MACQUARIE PARK COMMERCE CENTRE WATERLOO RD

SECTION 75W RESPONSE TO
NSW DEPARTMENT OF PLANNING QUERIES

S10758
9TH APRIL 2018

BLDG A & B LANEWAY

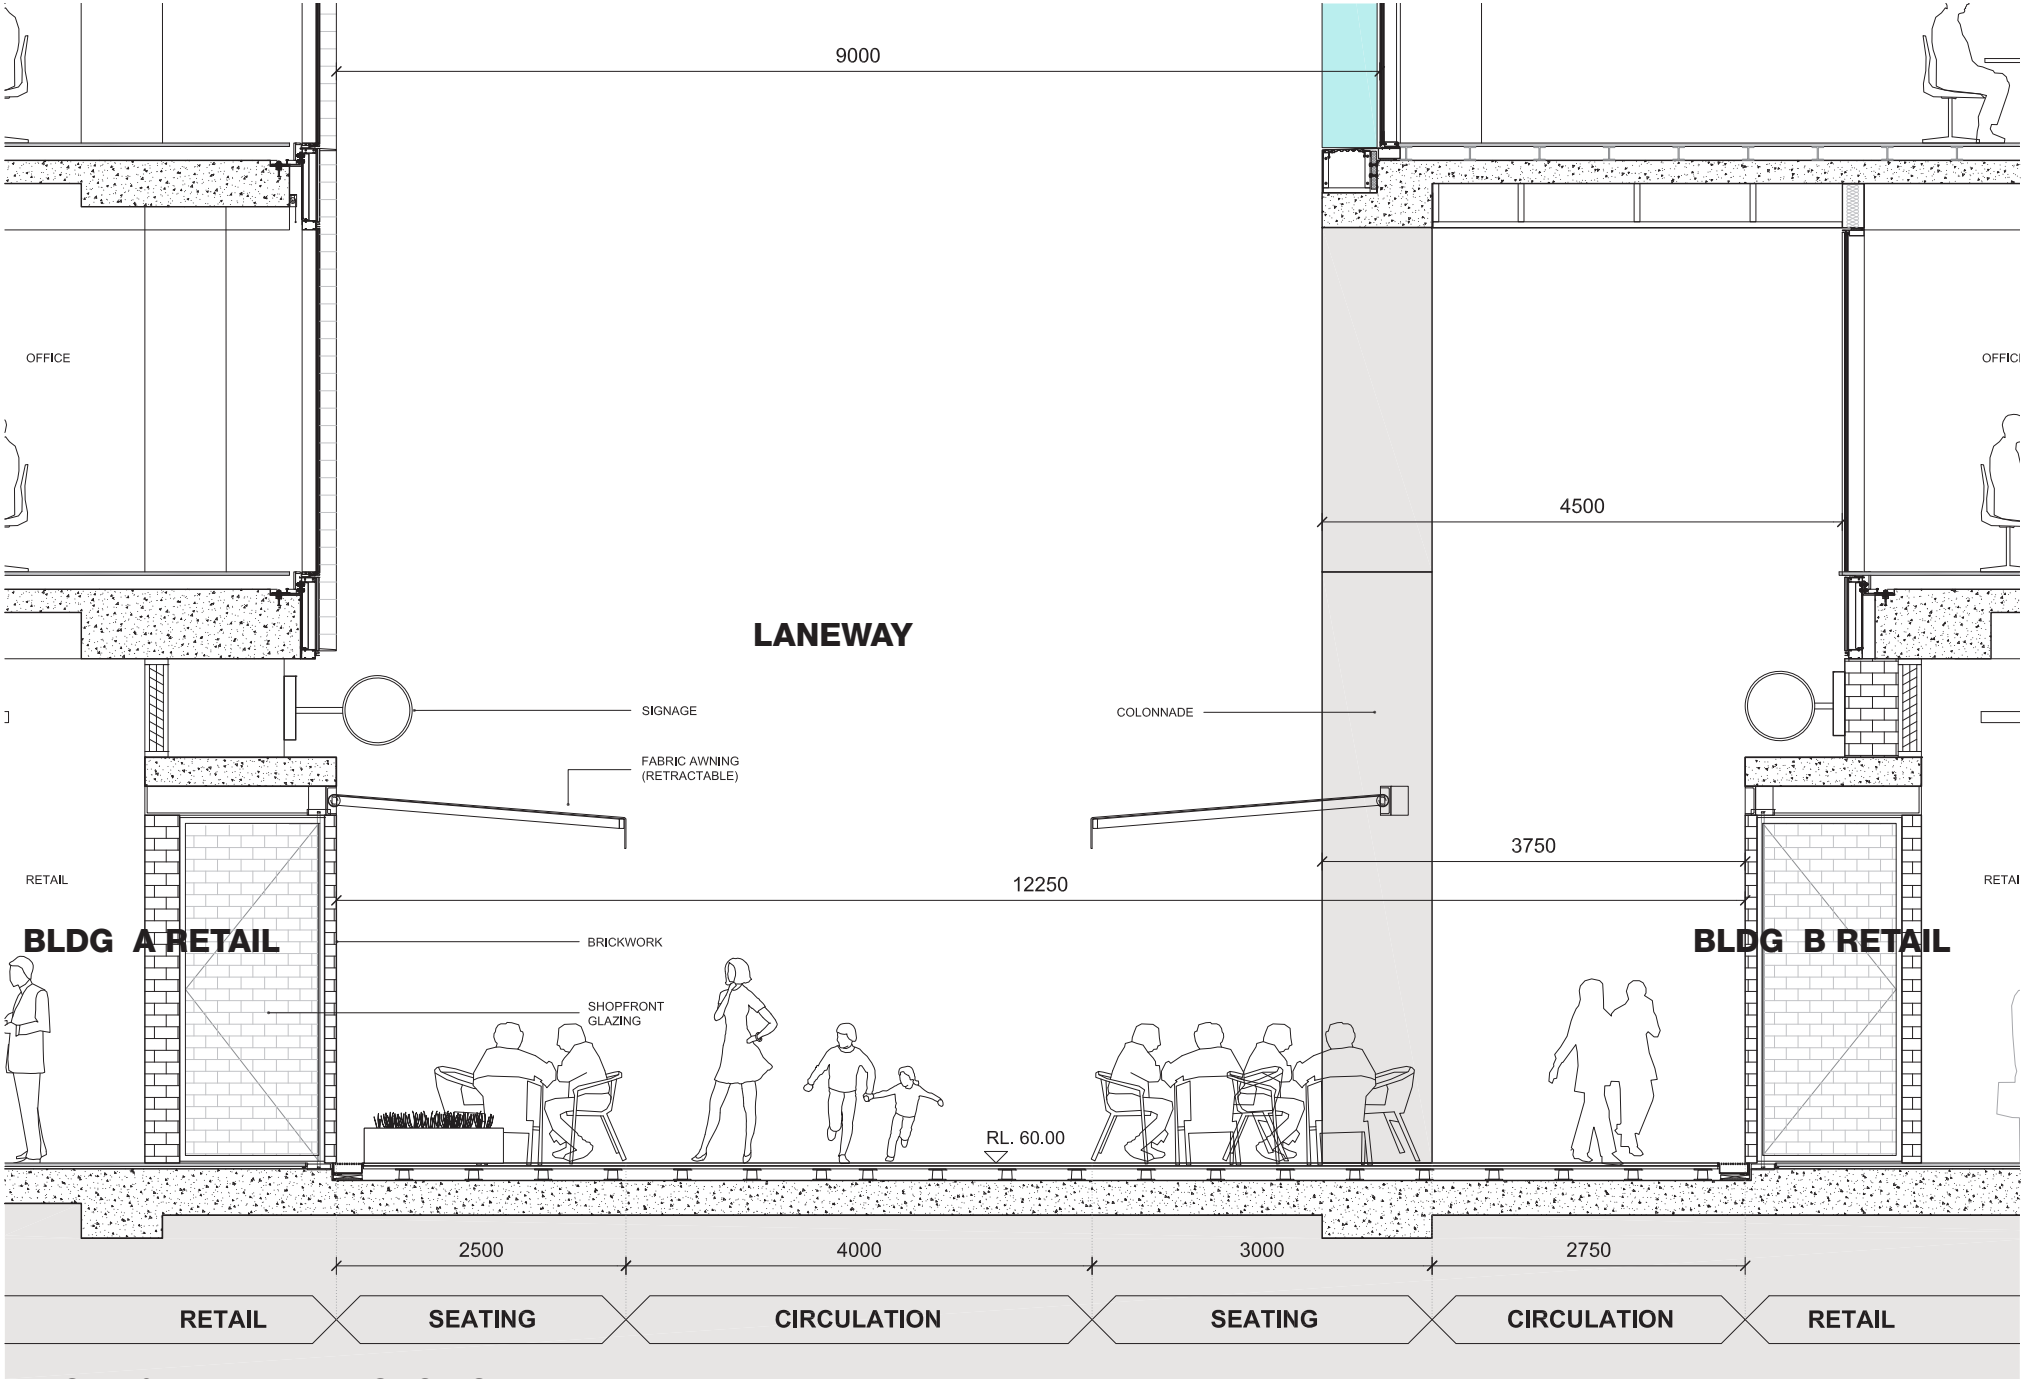
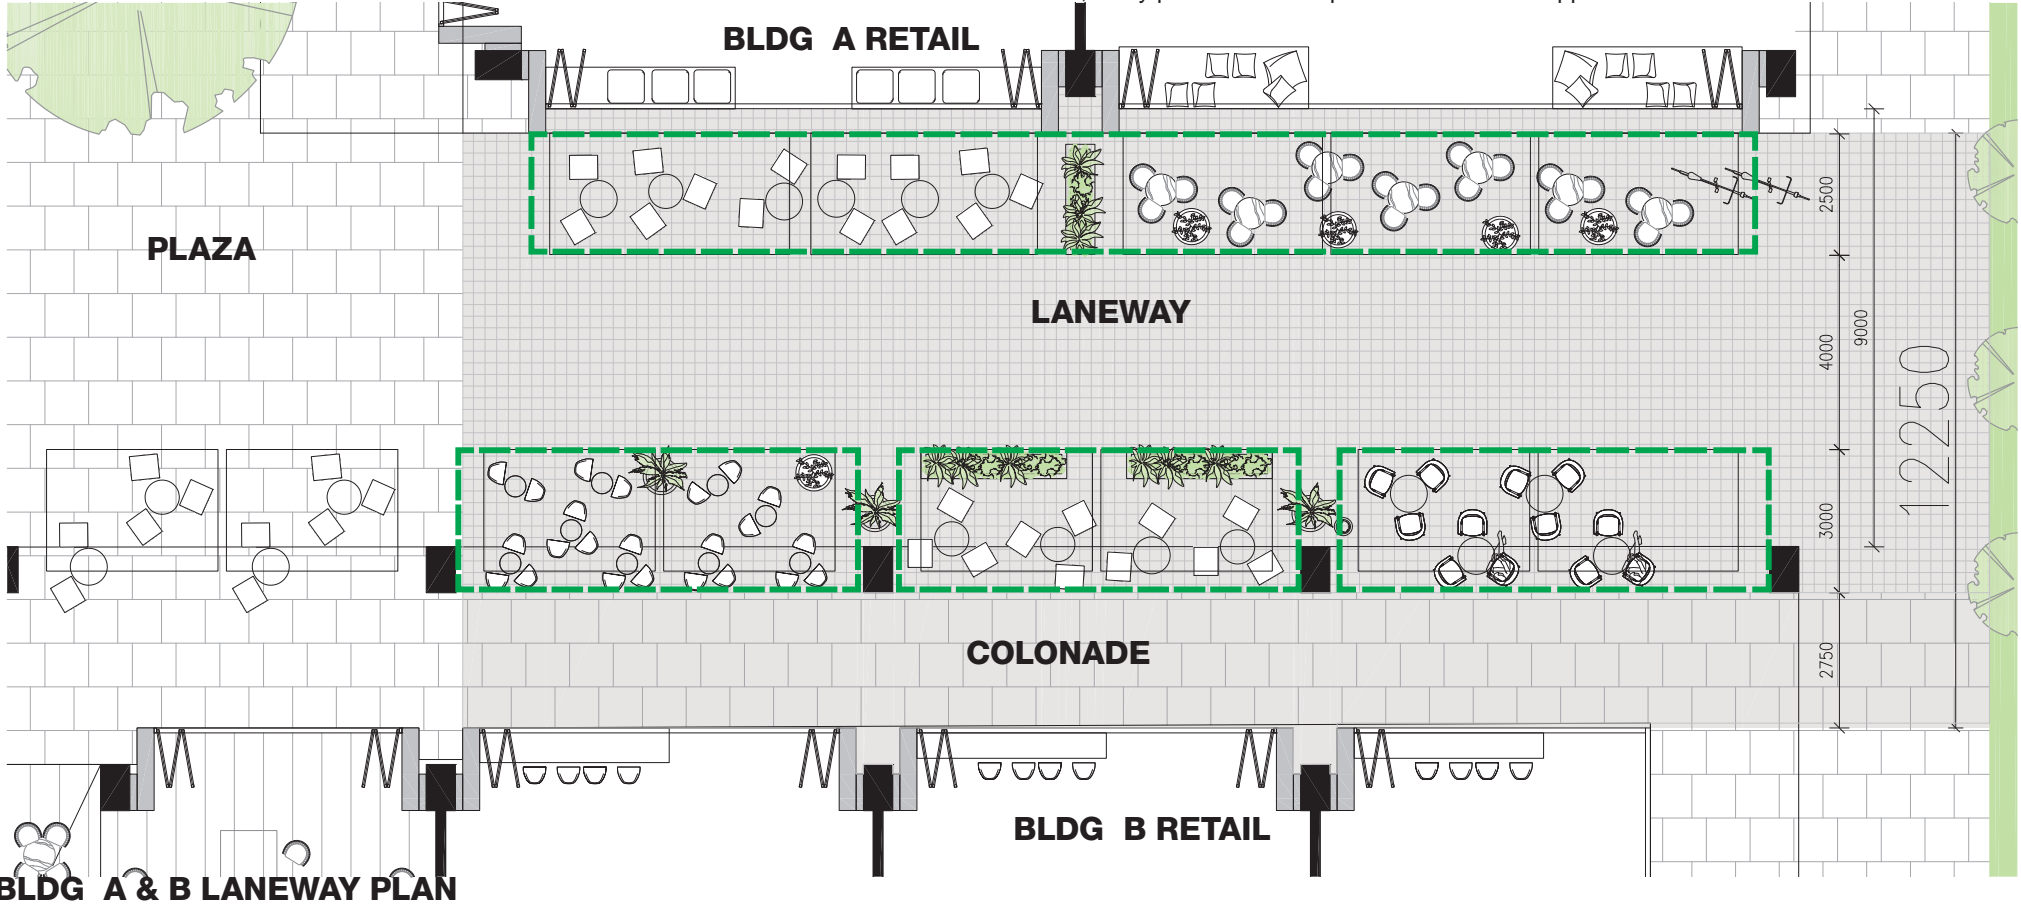
Laneways
1. Provide further consideration of the adequacy of the proposed laneway widths to accommodate pedestrian movements, as well as seating, landscaping and other elements. This should include an indicative layout of the laneways with dimensions.

The laneway between Bldg A & B has been designed to achieve a clear width of 12.25m between glazing lines & a physical 9m from colonnade to glass line. The additional walkway capacity is a response to the location, defined as a primary traffic zone and suitable thoroughfare is achieved between plaza and park. The overall width makes an allowance for a 2.5m minimum designated seating zone on each side. These dimensions have been tested with a pedestrian flow analysis width balances the need for ground level seating and activation against provision for clear unencumbered circulation between the station plaza and park. The 4m deep colonnade also provides sheltered access in adverse weather conditions, a key public benefit improvement from the approved scheme.

THROUGH TO PARK

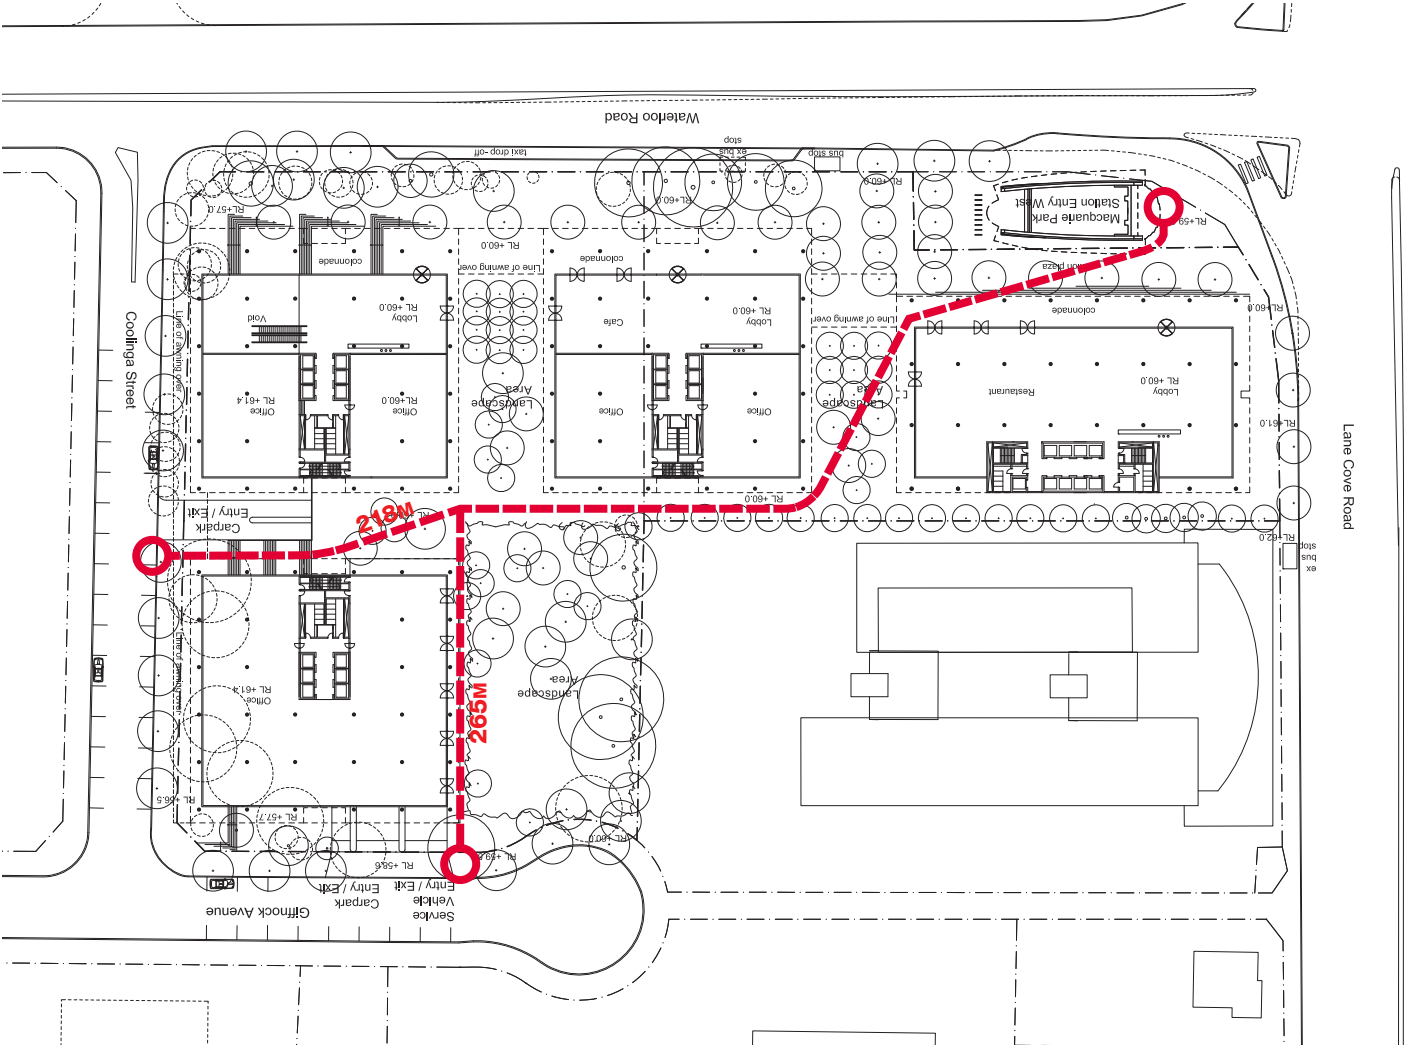
Laneways
2. Clarify the location of existing views and provide additional views through the laneways, particularly between Buildings A & B, comparing the approved and proposed scheme.

The following diagrams highlight the differences between the approved and proposed schemes for the laneway between Bldg A & B.

Whilst the dimensions of the laneway width has altered, the amenity and activation has significantly improved. These improvements are a result of:

1. the change in use at ground level which is now to be majority retail (food & beverage). By contrast, the approved scheme had a large proportion of commercial office allocation at ground level.
2. The introduction of colonade to Building B which provides sheltered thoroughfare between station plaza, other buildings on-site and the park. By contrast the approved scheme glazing line was recessed behind the column only.
3. Reduced through -site link distances, which is a result of Building A proportion change and landscape design amendments. (Refer diagrams page 9.)
4. Improved sense of space beyond the site as the adjacent Hyundai building is no longer visually terminating the laneway.

PROPOSED_LANEWAY BLDGS B & C

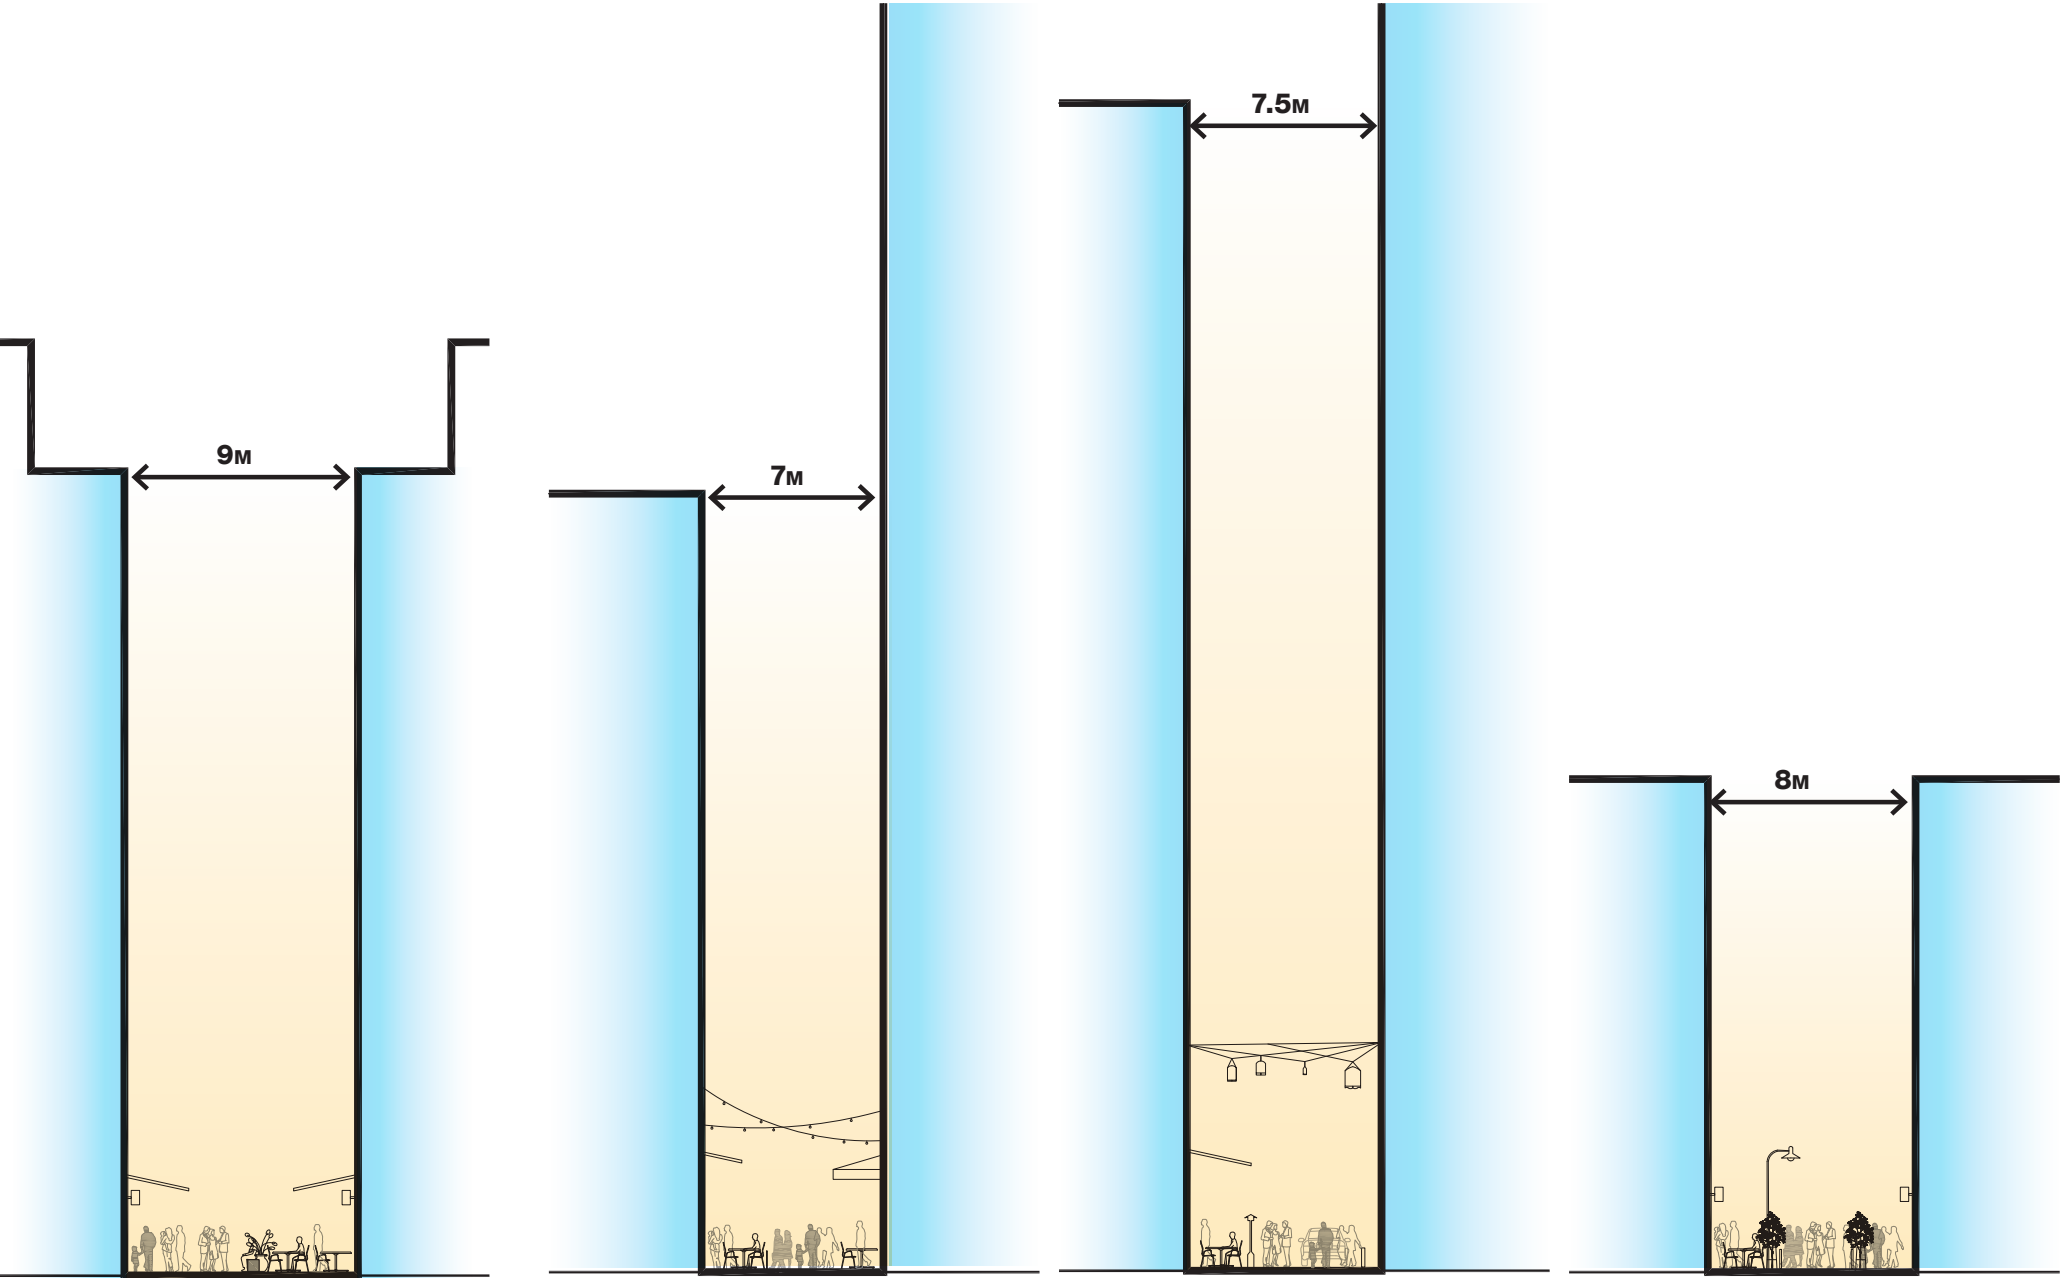
Laneways
2. Clarify the location of existing views and provide additional views through the laneways, particularly between Buildings A & B, comparing the approved and proposed scheme.

The following diagrams highlight the differences between the approved and proposed schemes for laneway between Bldg B & C.
Whilst the dimensions of laneway width has altered, the amenity and activation has significantly improved.
These improvements are a result of:
1. the change in use at ground level which is now to be majority retail (food & beverage). By contrast, the approved scheme had a large proportion of commercial office allocation at ground level.
2. Alternate landscape approach to allow for visibility through to the park beyond.
